Safety Notice # 1 of 2005 Defective One Way Valve Recall

Circle Seal Controls, Inc. One-Way Valve Part P214-180.

Kirby Morgan helmets, BandMasks and replacement parts. KMDSI P/N 555-195 One Way Valve and P/N 505-060 One Way Valve Assembly.

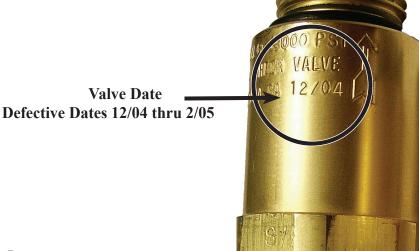
Kirby Morgan Dive Systems, Inc. (KMDSI) has learned that a single batch of non-return (one-way) valves manufactured by Circle Seal Controls, Inc. may be defective. These valves are used on all Kirby Morgan masks and helmets manufactured for surface-supplied diving. The valves in question are date stamped on the valve body and fall within the date range 12/04 to 02/05. If you have a valve like this on your helmet, **YOU SHOULD STOP USING IT IMMEDIATELY** and replace it with a valve that does not fall within this date range.

In the defective valves, small slivers of the Teflon wiper (used in these valves as part of the sealing mechanism) may be cut off the Teflon wiper and interfere with the poppet that seals the valve. When this occurs it is possible for air from the helmet or emergency gas supply to be lost through the valve if the diver's umbilical has been severed or umbilical pressure is lost for any reason. This could lead to the diver suffering severe personal injury, known as a "squeeze," or death.

If you have one of these valves on your helmet, or are carrying a valve like this as a spare, **DO NOT DIVE WITH IT!** Please return it immediately to KMDSI, or any of its dealers, for a free replacement. KMDSI can be reached at 1430 Jason Way, Santa Maria, CA 93455. Telephone 805-928-7772, FAX 805-928-0342. Email kirwin@kirbymorgan.com. Website www.kirbymorgan.com.
